CITY OF SAN ANTONIO

Re: Hallie Heights

MDP # 756

The City Staff Development Review Committee has reviewed Hallie Heights Master Development Plan M.D.P. # 756. Please find enclosed a signed copy for your files. Your plan was accepted, however please note the following:

HALLIE HEIGHTS SUBDIVISION
35 ACRES
MASTER DEVELOPMENT PLAN

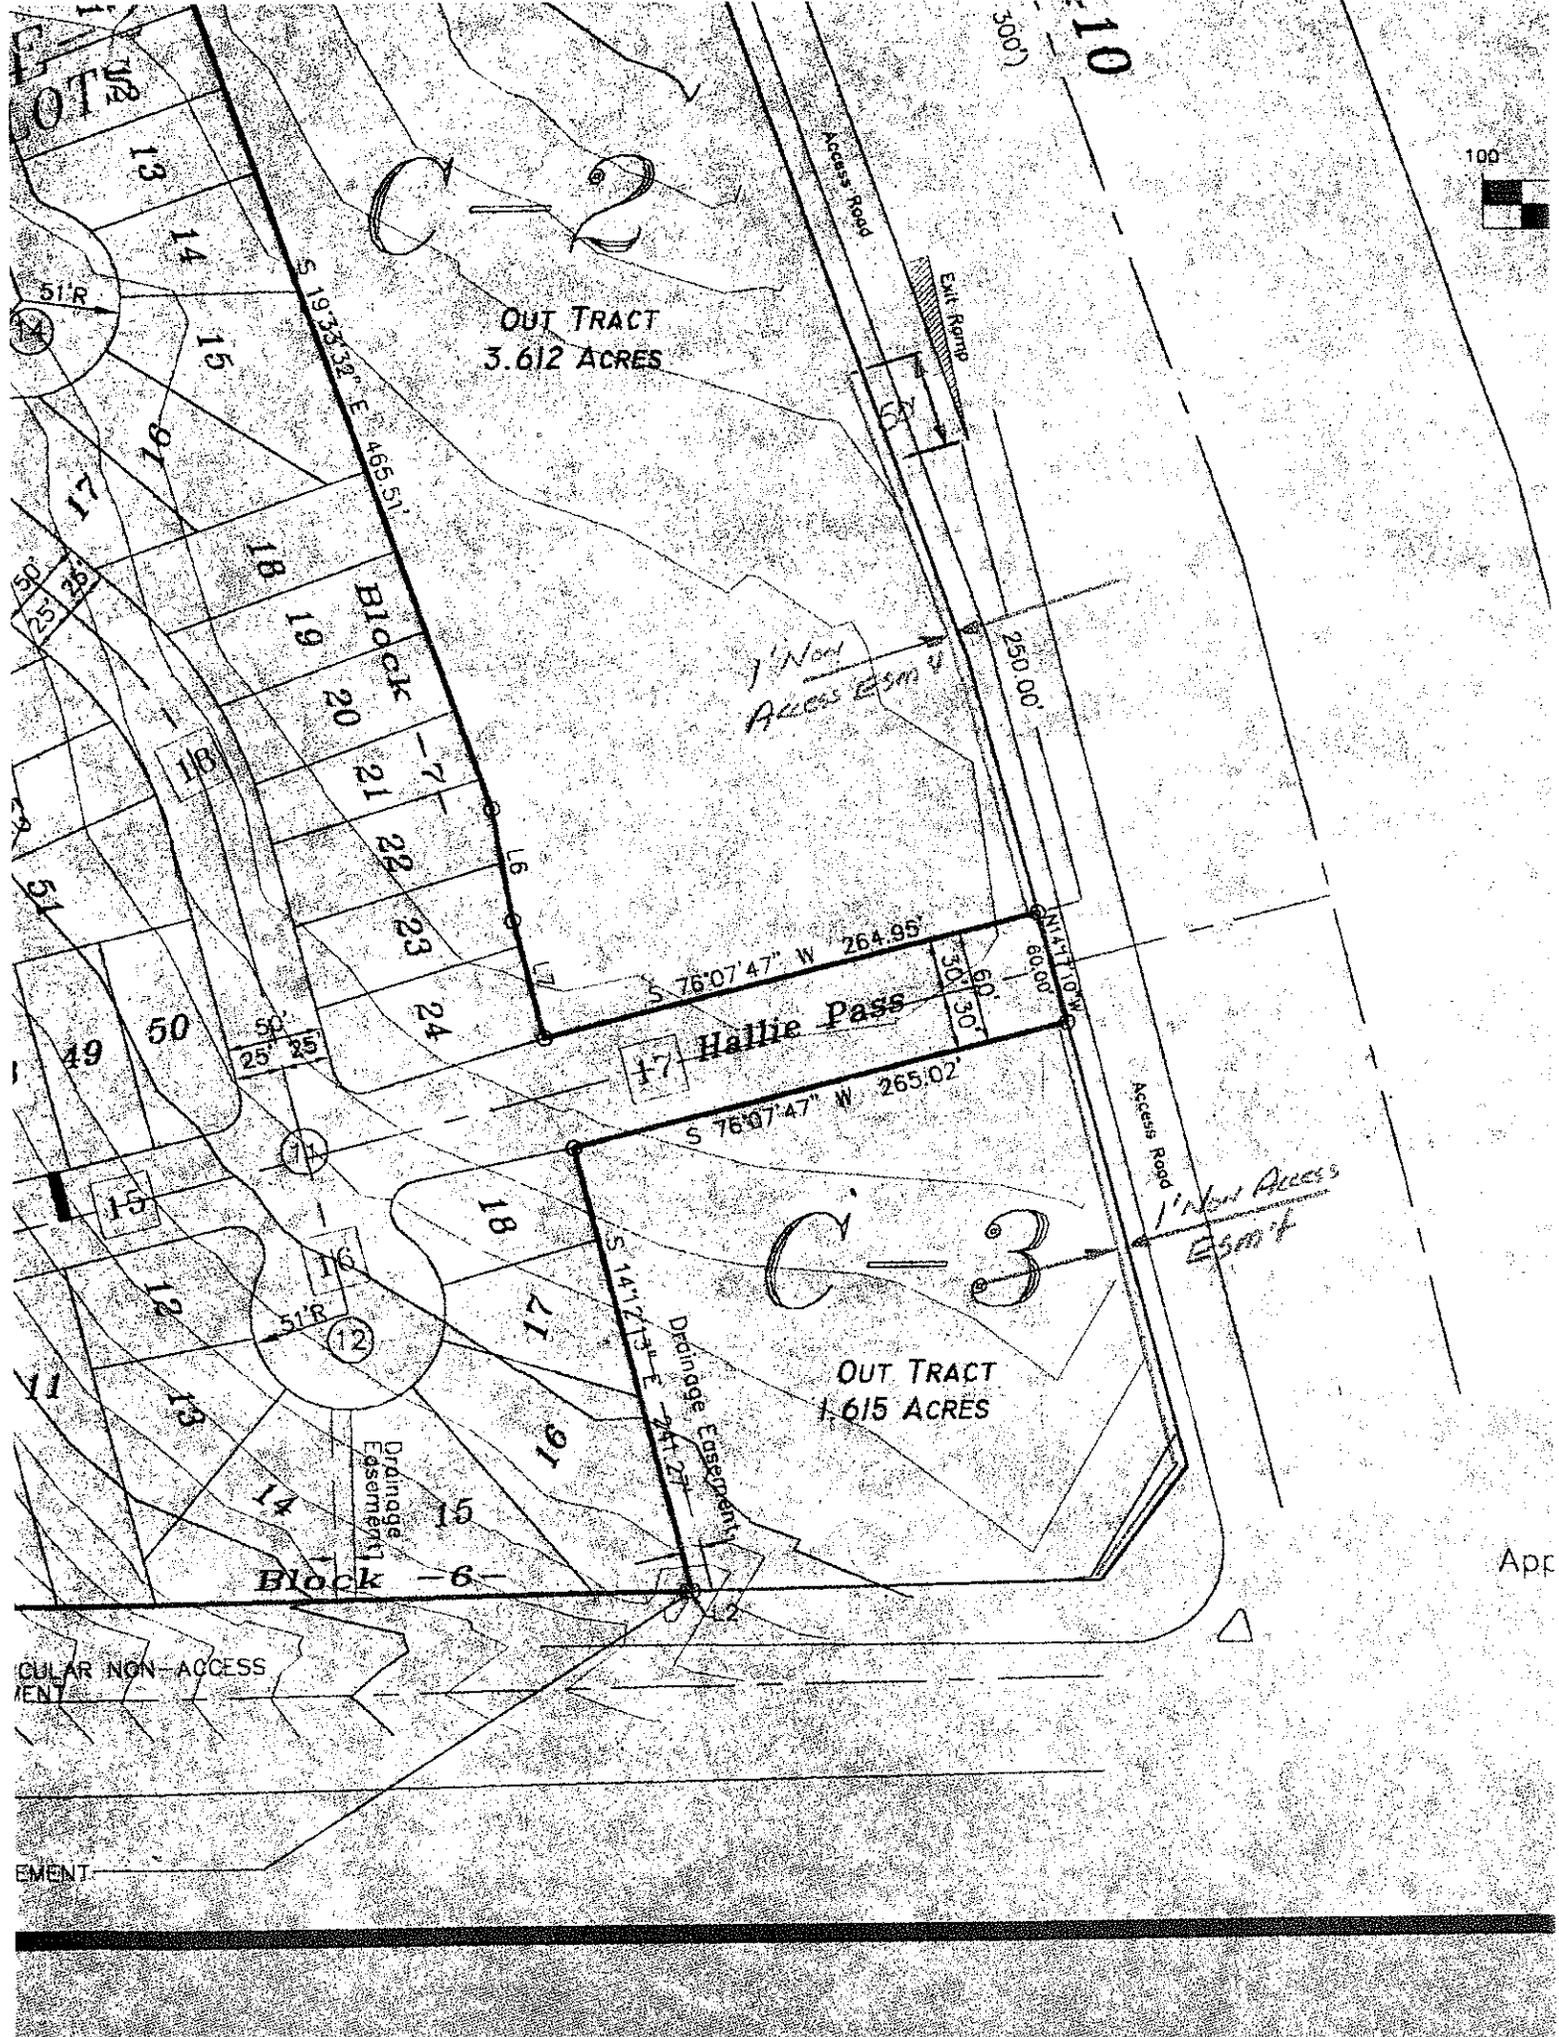
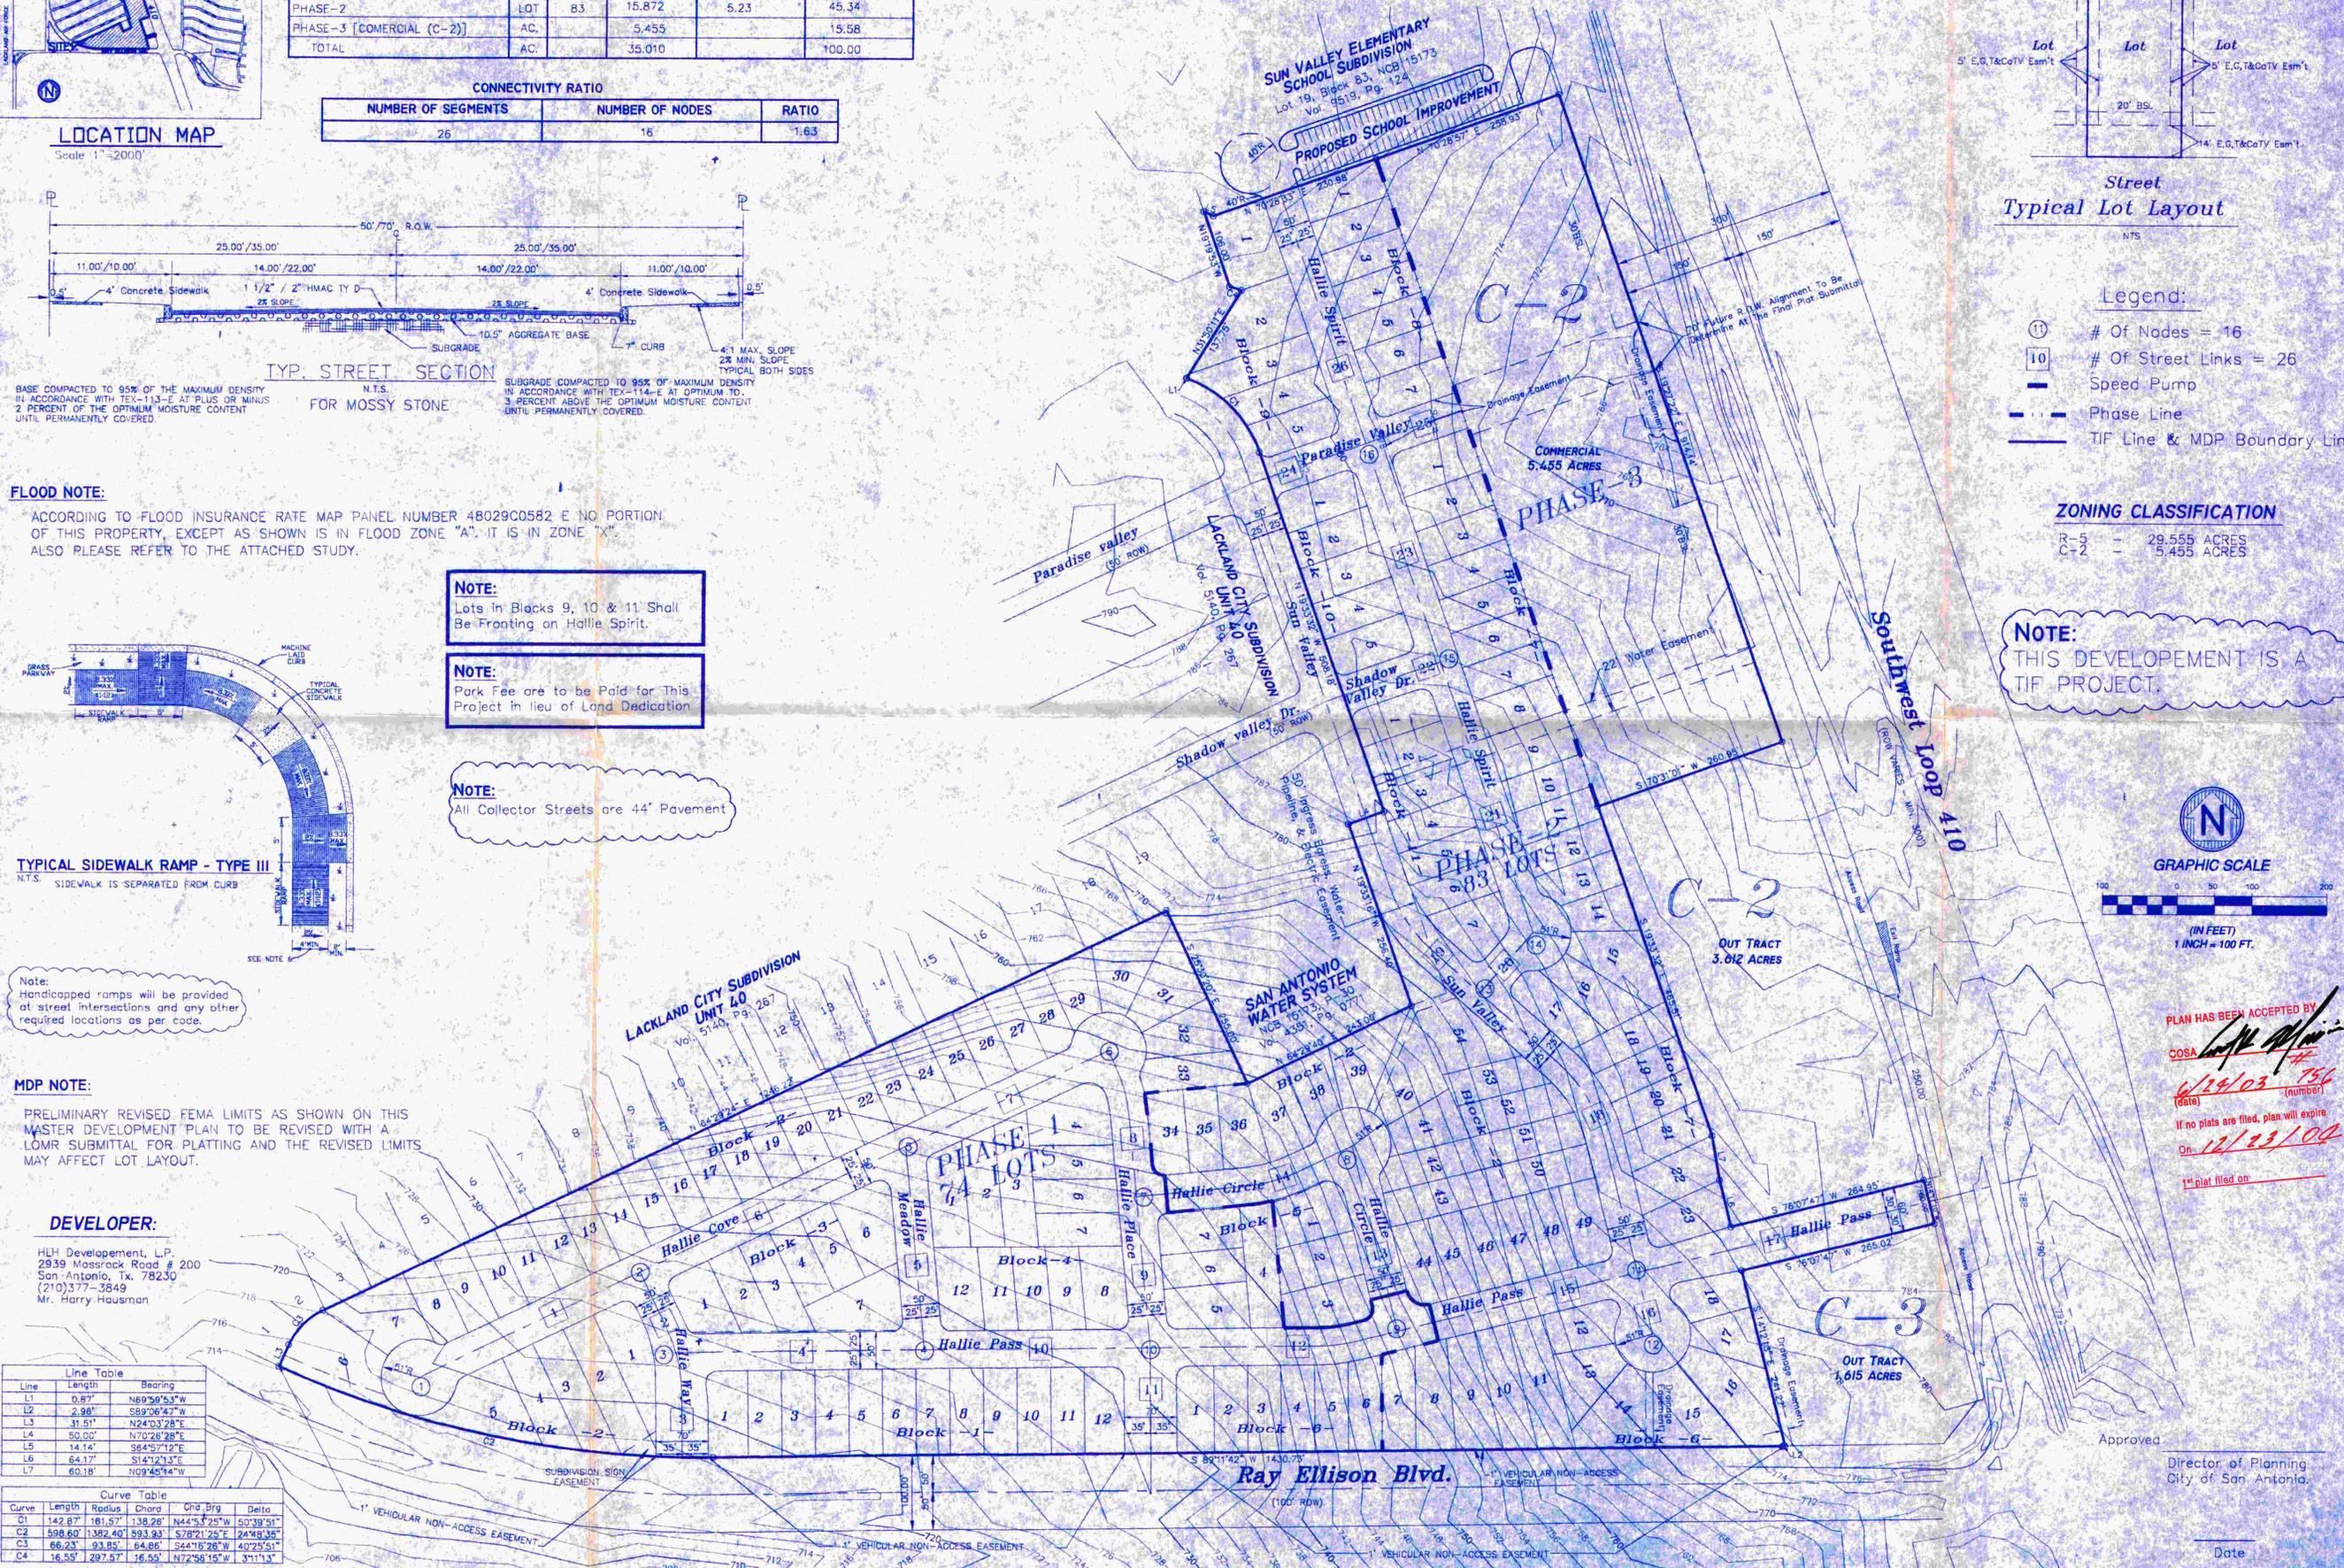
- The Neighborhood Action Department (NAD) as part of their conditional approval impose the following conditions to be met by the developer at the time of final plat submittal:

- Project proximity to schools, libraries, parks and health facilities
 - Linkage with other area public improvement projects
 - Project plan for underground utility conversion

- Comprehensive site plan and structural land use assessment
 - Project plan for underground utility conversion
 - Maximum front setback requirements for uses permitted within a c-2 Zoning district.

- Section 35-343 (m) of the Unified Development Code (UDC) for the City of San Antonio
 - Neighborhood Action Plan
- In consideration of public safety and convenience, excessive grades by reason of topography should be avoided in street layouts and arrangements.

- Any access and R.O.W. issues along state facilities will need to be resolved with the Texas Department of Transportation (TXDOT). For information about these requirements you can contact TXDOT at 615-5814.

- This development will need to comply with tree preservation ordinance #85262. For information about these requirements you can contact Building Inspections at 207-7102.

- It will be expected that you will plat all of the property depicted in your Master Development Plan (M.D.P.) to include floodplains, drainage areas and open space.

- Development Services, Engineering Section has indicated as part of their conditional approval, the following conditions shall be met by the developer at the time of final plat submittal:

1. Right-turn deceleration lanes are necessary and should be placed at all access points on IH 410 and Ray Ellison Blv'd.
 2. Left-turn lanes should be placed at all access points on Ray Ellison Blv'd.

3. Stub-out streets should not be proposed simply to satisfy the connectivity ratio.
- The Parks and Recreation Department as part of their conditional approval impose the following:

1. The applicant has selected to meet the park dedication requirement through the payment of a fee in-lieu of dedication. Based on documentation submitted by the applicant, the fee for this project is \$16,000.00. Prior to the recordation of the first plat filed under this Plan, the amount of \$16,000.00 is to be paid to the City of San Antonio Parks and Recreation Department.
